LAKE PONTCHARTRAIN, LOUISIANA AND VICINITY
LAKE PONTCHARTRAIN BARRIER PLAN
DESIGN MEMORANDUM NO. 2 - GENERAL DESIGN
SUPPLEMENT NO. 5B

NEW ORLEANS EAST
LAKEFRONT LEVEE
PARIS ROAD TO SOUTH POINT

LMVED-TD (NOD 20 Jun 72) 1st Ind
SUBJECT: Lake Pontchartrain, Louisiana and Vicinity, Lake Pontchartrain
Barrier Plan, General Design Memorandum No. 2, Supplement No. 5B,
New Orleans East Lakefront Levee, Paris Road to South Point

PLAN
SLUICE GATE STRUCTURE
Scale: 1/4" = 1'-0"

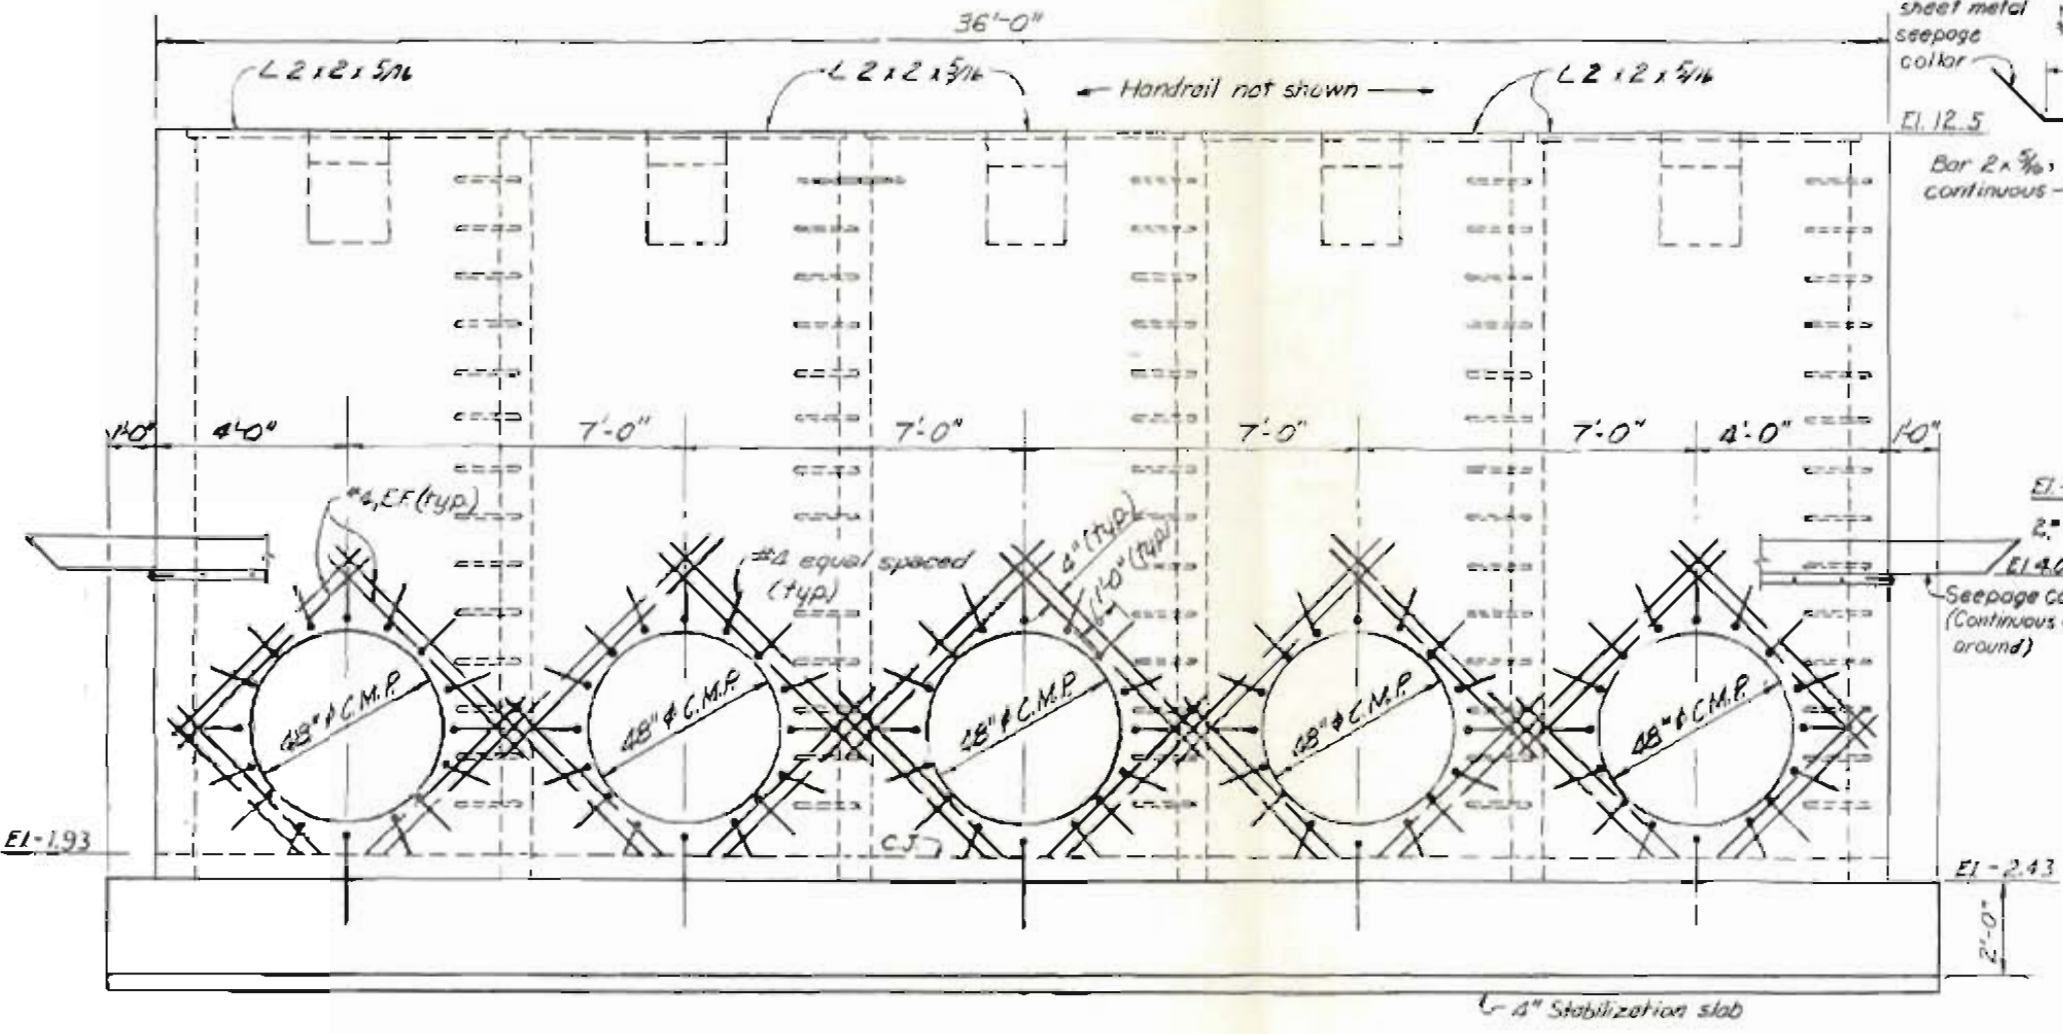
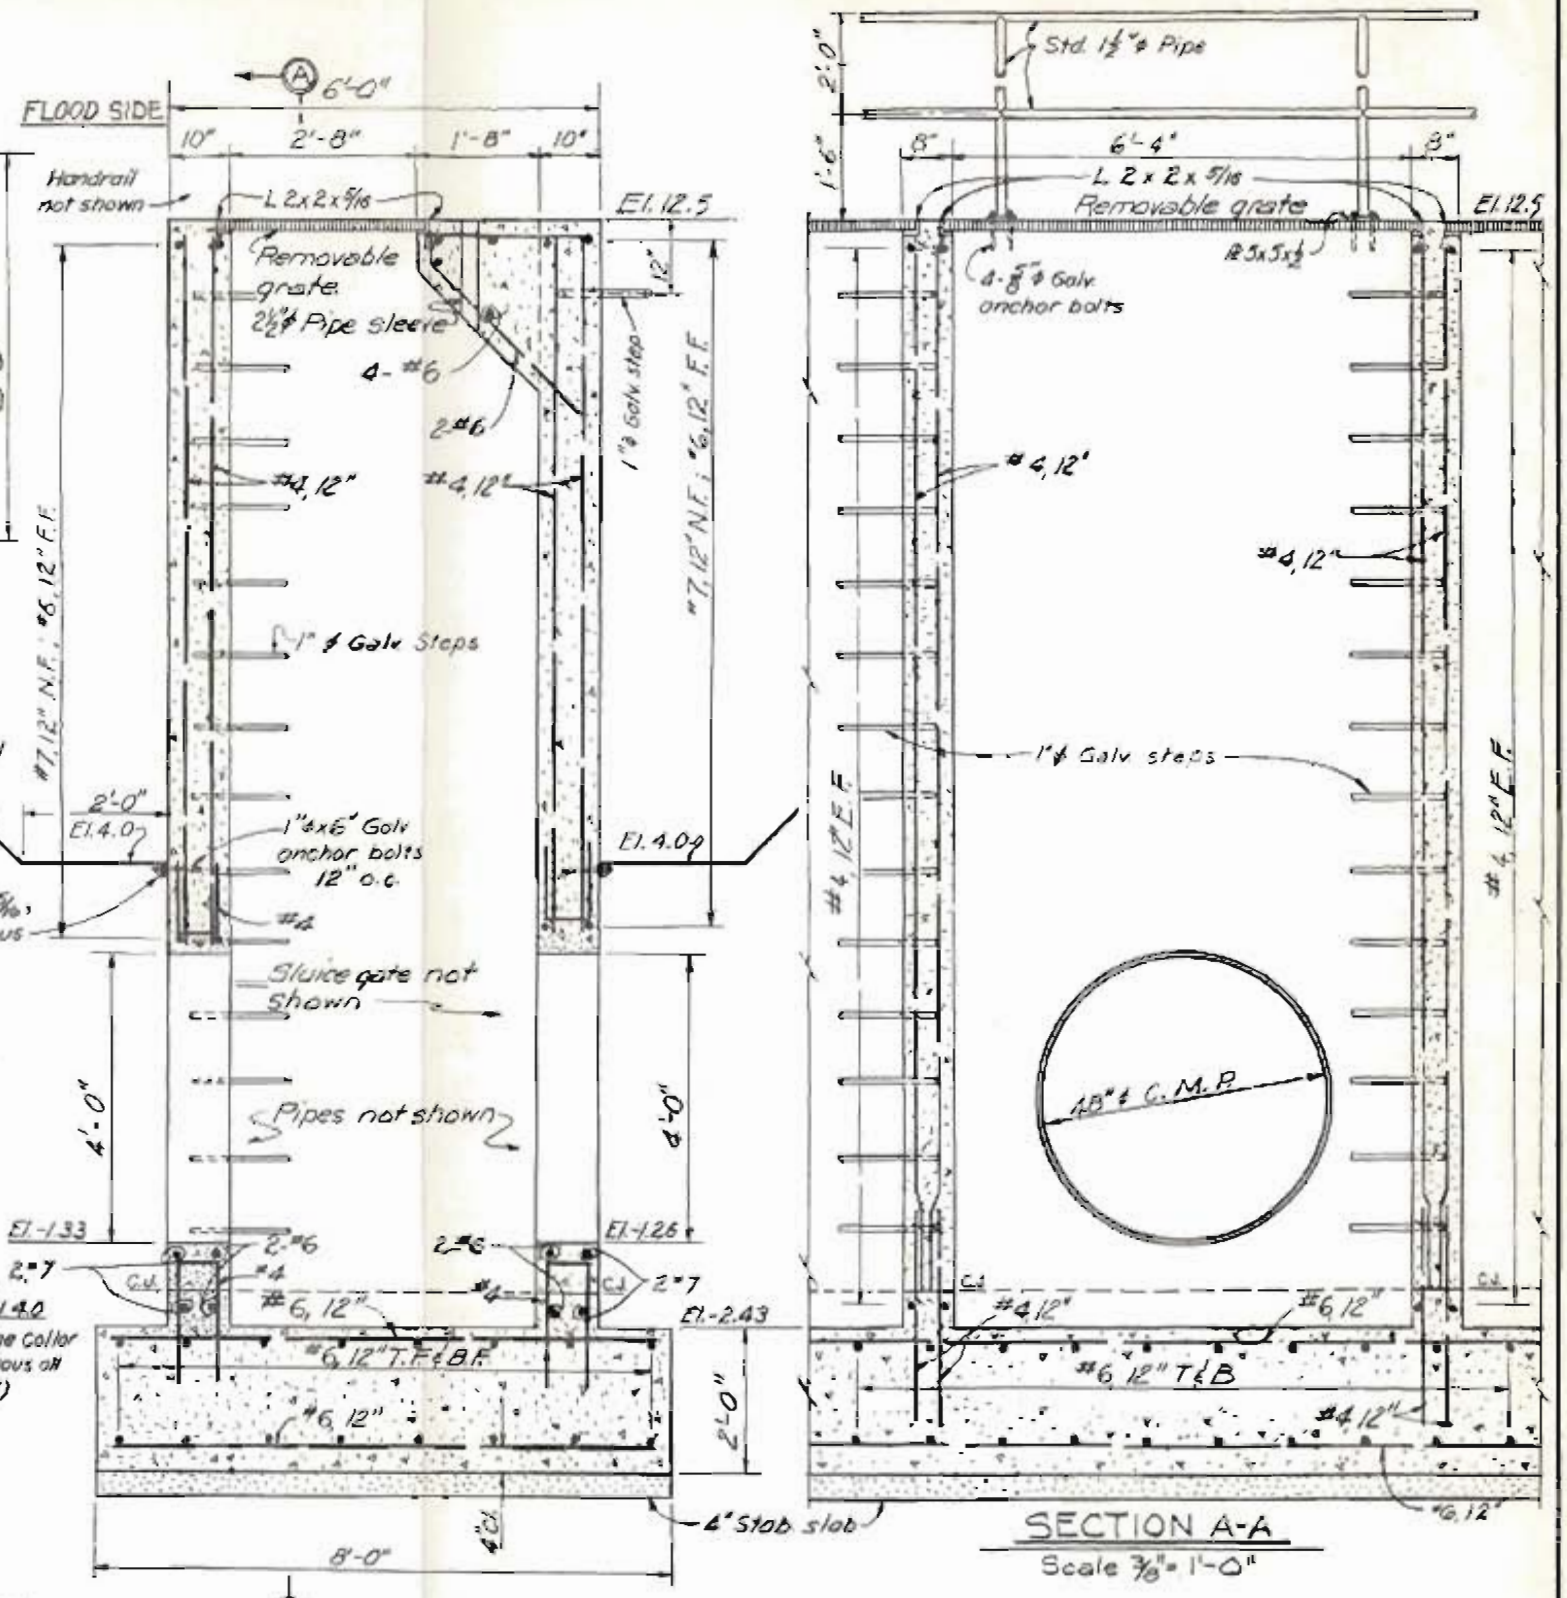
- b. The horizontal collar described in the seventh sentence and shown on Plate 54 should be deleted.
 - c. Consider deleting the stoplog support sill and baffle walls from the outlet structure (See Plates 34 and 56). Flap gates could be maintained by using a sandbag or earth dike cofferdam since the normal depth of water will be less than 3 ft.

8. Plates 34, 55, and 56. The training walls should be flared at a rate of 1 to 6 and the channels transitioned to the full section at the same rate of expansion as marked in red on Plate 34. This will reduce turbulence in the outlet structure due to eddy action.

9. Para 8. Concur. The training walls on the outlet side of the structure will be flared at the rate of 1 on 6 with the channels likewise transitioned to full section. Inlet basin training walls will be flared at 1 on 2. These changes will be reflected in the plans and specifications.
